# UNITED STATES PATENT AND TRADEMARK OFFICE

APPLICATION NO.	FILING DATE	FIRST NAMED INVENTOR	ATTORNEY DOCKET NO.	CONFIRMATION NO.
10/710,713	07/29/2004	Scott D. Maxwell	03-1405 (BOE 0509 PA)	4712
44702	7590	05/30/2006	EXAMINER	
OSTRAGER CHONG FLAHERTY & BROITMAN PC 250 PARK AVENUE, SUITE 825 NEW YORK, NY 10177			ROGERS, DAVID A	
			ART UNIT	PAPER NUMBER
			2856

## Office Action Summary

10/710,713

Figure 1

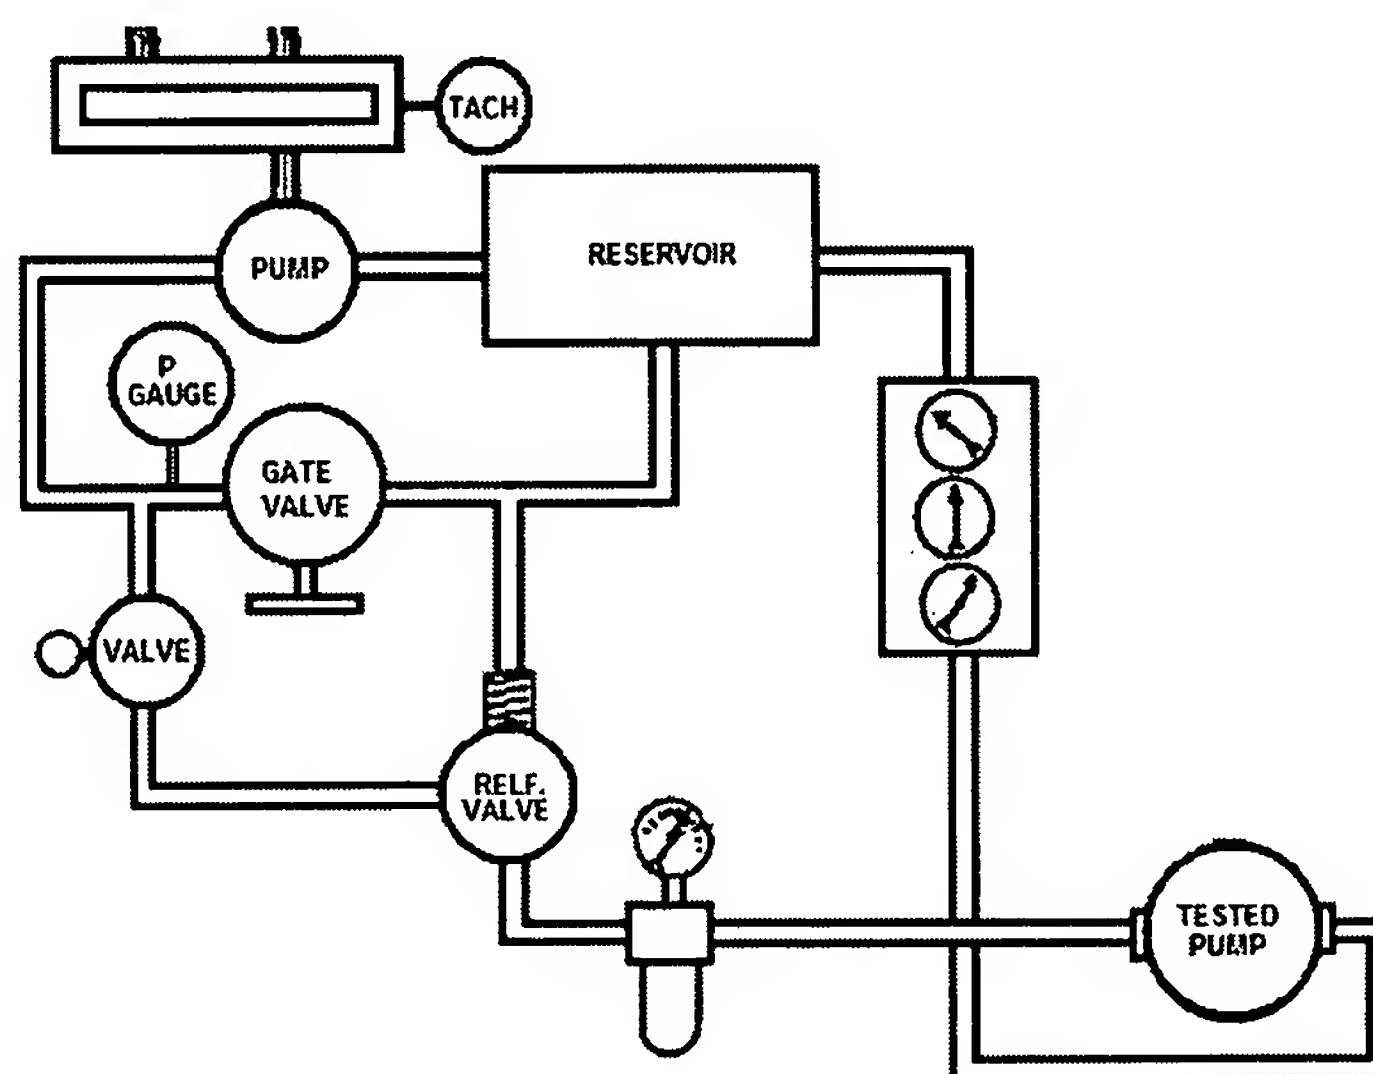
Shepard teaches a method and device for testing hydraulically actuated devices (reference item 56), hereinafter referred to as a device under test (DUT). The general schematic is shown below as figure 1.

The apparatus comprises a first hydraulic fluid reservoir (reference item 32) and a fluid moving pump (reference item 30) that is fluidically coupled to the first hydraulic reservoir. The apparatus also comprises a plurality of pressure gauges (reference items 34 and 50), including an additional pressure gauge on

the flow rater (reference item 68), that can detect the pressures at various points in the hydraulic circuit. As seen in figure 3 there is an indication of the fluid pressure either at reference item 50 or at reference item 68. The flow rater also comprises a temperature sensor for monitoring and indicating the temperature of the hydraulic fluid.

*Figure 2*

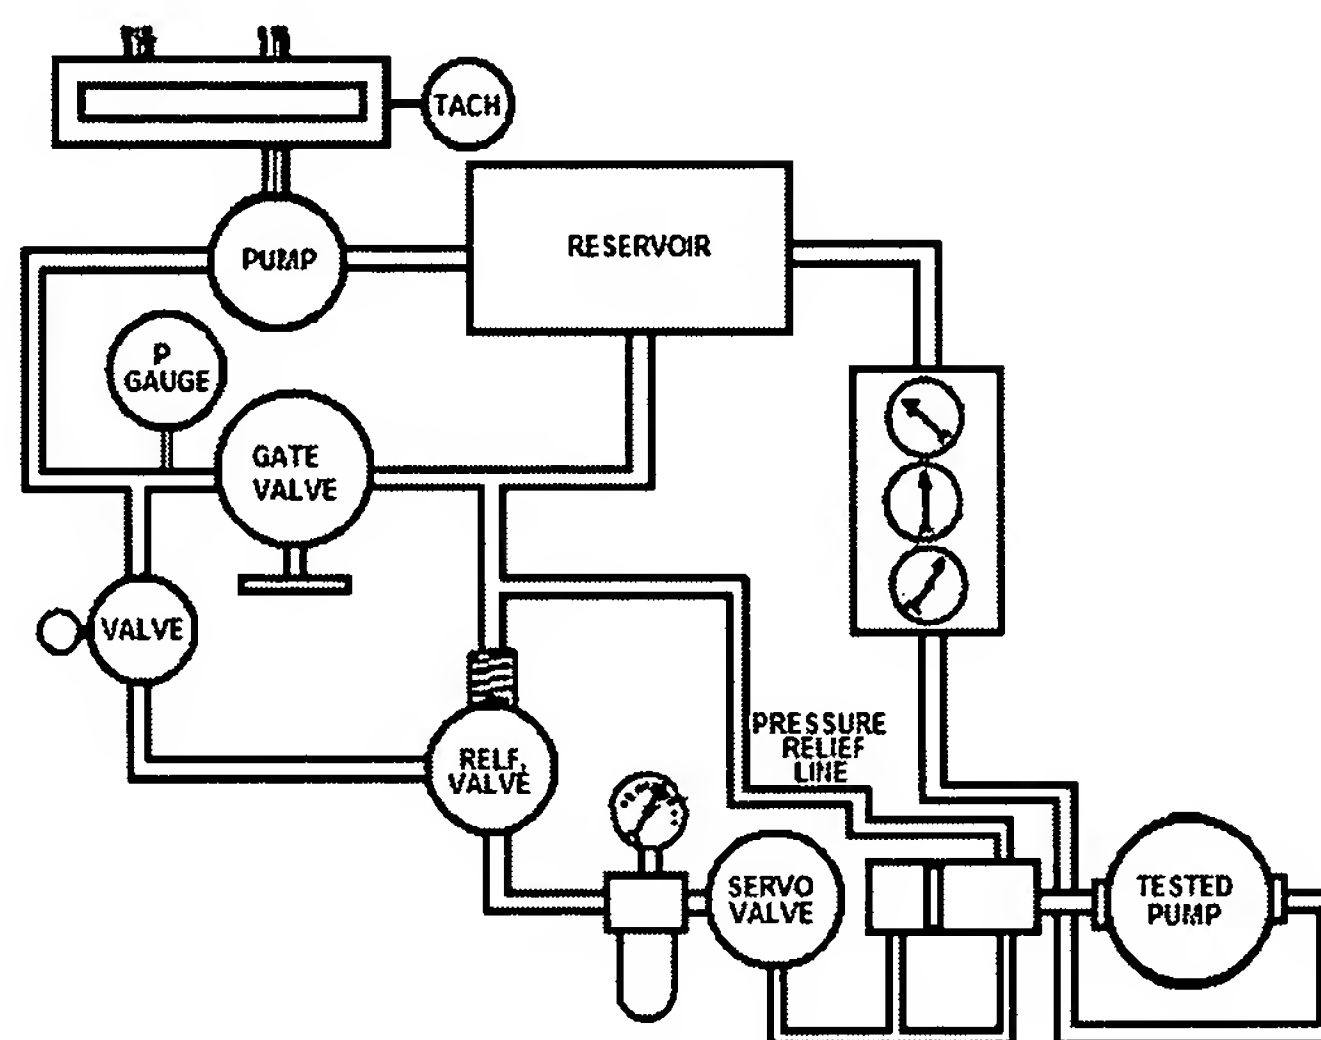
Beran *et al.* teaches an apparatus for testing a device (reference item 6) using a hydraulically controlled piston (reference item 2) located in a housing (reference item 1). The piston defines two chambers (reference items 3 and 4) inside of the housing where chamber 3 can be a pressure side and chamber 4 can be an output side. The chamber shown as reference item 4 would be a second hydraulic reservoir. The device also comprises a relief valve (reference item 15) and servo valve (reference item 10) that is capable of separately adjusting the pressures in the two chambers. Beran *et al.* teaches that their system is beneficial in that it allows the DUT to be subjected to the variable loads, e.g., jerk loads, which simulate actual process loads.

With regard to claim 14 it would have been obvious to add a pressure gauge after the servo valve/piston arrangement shown in figure 2 above so that the test can record the actual pressures used on the DUT.
